Technical Bulletin

Repairing Cabriolet Top

Number
9508

Models Affected: *911 Carrera Model Year 1995*

Figure 5

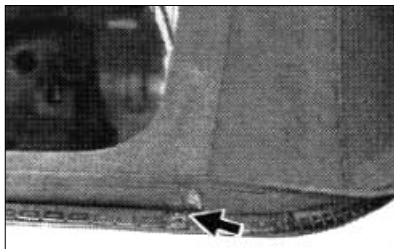
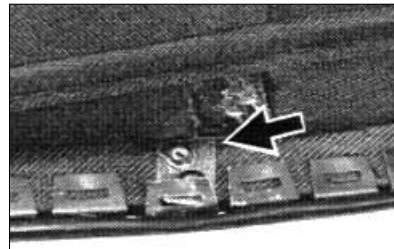
The radius for storing the rear window is too small.

As a solution, from the end of June 1994, spring supports are installed on the left and right sides of the top tensioning frame. With this solution, proper storage of the rear window is assured.

The two spring supports can be installed into earlier vehicles using pop-rivets (Arrows in figure 5 and 6).

- Bend open the steel tabs on the tensioning bow for the Cabrio top material and install the spring support as shown in Figure 6.
- Drill one 3.2 mm hole through the spring support and into the tensioning bow and secure the spring support so that it is parallel with the rear window opening (Figure 7).

Figure 7

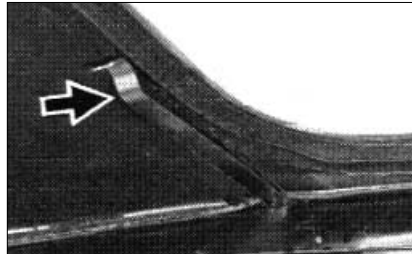
- Open the headliner zipper.
- Install the spring supports through the cuts in the material from the inside of the vehicle (Figure 7). For holding the alignment of the spring supports, a second person is needed.

Figure 9

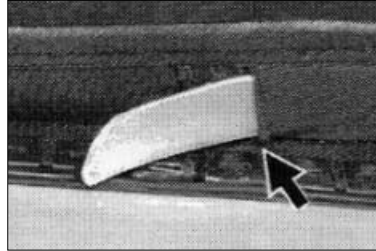
- Carefully insert the aluminum filler piece into the opened seam of Cabrio top (Figure 9).

- The aluminum filler piece must fit fully into the seam slot and should not protrude from the seam slot.
- Flip down the Cabrio top material and form the aluminum filler piece to the body contour.

Figure 10

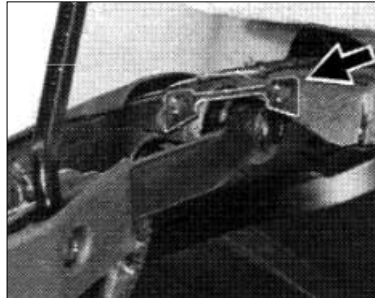
- Open the Cabrio top fully (remove windstop if installed).
- In the area of the main bow hinge, move the Cabrio top material to the side and check if the folding bow tension strap is fully glued on the main bow. If not, reglue the strap to the main bow.
- Cut the tensioning strap off flush with the edge of the main bow.
- Cut the tensioning strap off at the folding bow.
- Position the new tensioning strap bracket on the main bow and mark the holes for drilling. The bracket should be located approximately 1-2 mm below the upper edge of the main bow (Figure 10).

- Drill holes with a 3.3mm drill bit approximately 12mm deep.
- Slightly countersink the holes and tap them for M4 threads. Remove the shavings carefully.
- Install the clamping plate onto the new tensioning strap and install onto the folding bow.

Figure 11

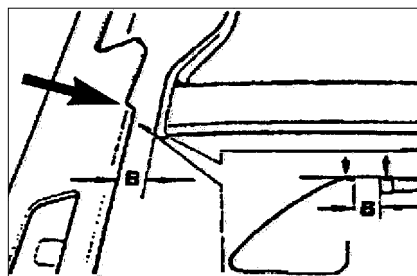
- Check for proper clearance of the top folding bow to the side rails of the Cabriolet top frame (dimension "B" in Figure 11). Dimension "B" should be 5 to 7 mm. If less, it is necessary to rework the side rails in the area indicated by the arrow in Figure 11 to gain clearance for the folding bow.
- Remove the plastic clamps near the folding bow on the right side that are holding the Cabriolet top wiring harness to the cabriolet top frame. Use electrical tape to secure the harness to the top frame. **Be certain the harness does not interfere with the smooth operation of the top folding bow.**

Drawing 1 (Concern 4)

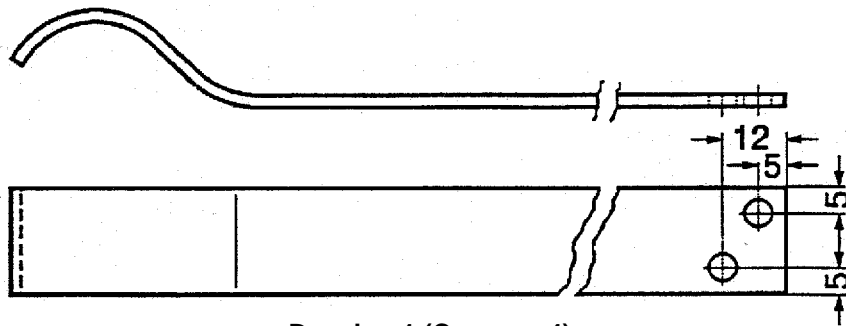
- Fully close and lock the Cabrio top.
- Using drawing number 1, on page 9, mark and center punch the hole locations on the spring support.
- Pull up the Cabrio top material in the area of the rear window. Cut the material approximately 25 mm next to the top longitudinal seam for 8mm (Figure 6)

Drawing 2 (Concern 5)
Right Side Driving Direction

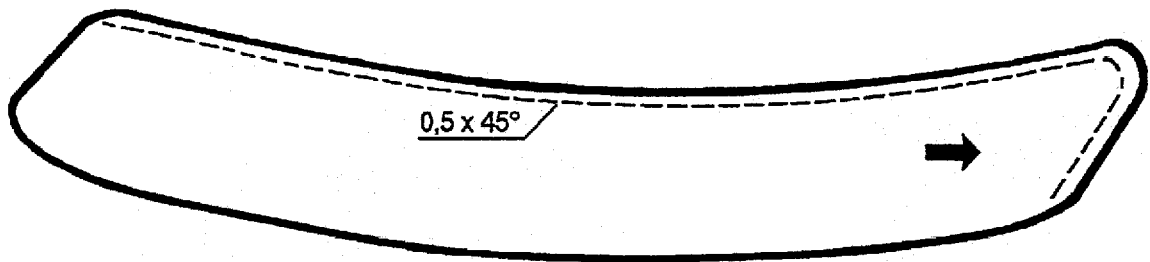
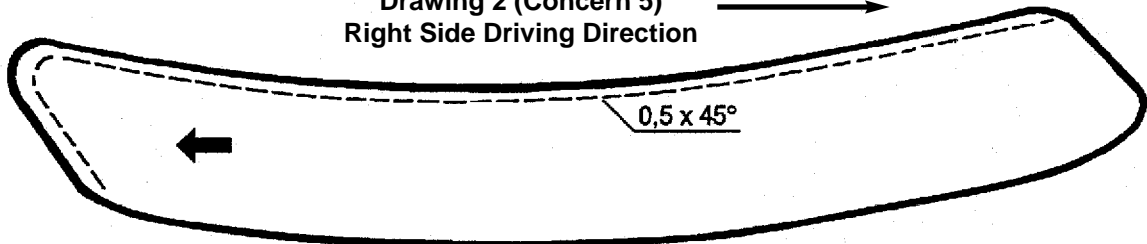
- Fully close and lock the Cabrio top.
- Refer to drawings 2 and 3 on page 9. Copy these drawings and cut them out. Place the cut-out onto the vehicle top on the correct sides and check its contour against that of the vehicle (Figure 8).

- Trace the template onto a 1.0 mm thick sheet of aluminum and cut or saw the piece out. **All edges must be made smooth and rounded. No sharp edges! Otherwise, the top canvas may get damaged.**
- Flip up the Cabrio top material in the area as shown in Figure 8.
- Carefully loosen the glued area between the top material and the seam using an appropriate tool such as 9134 or 9187.
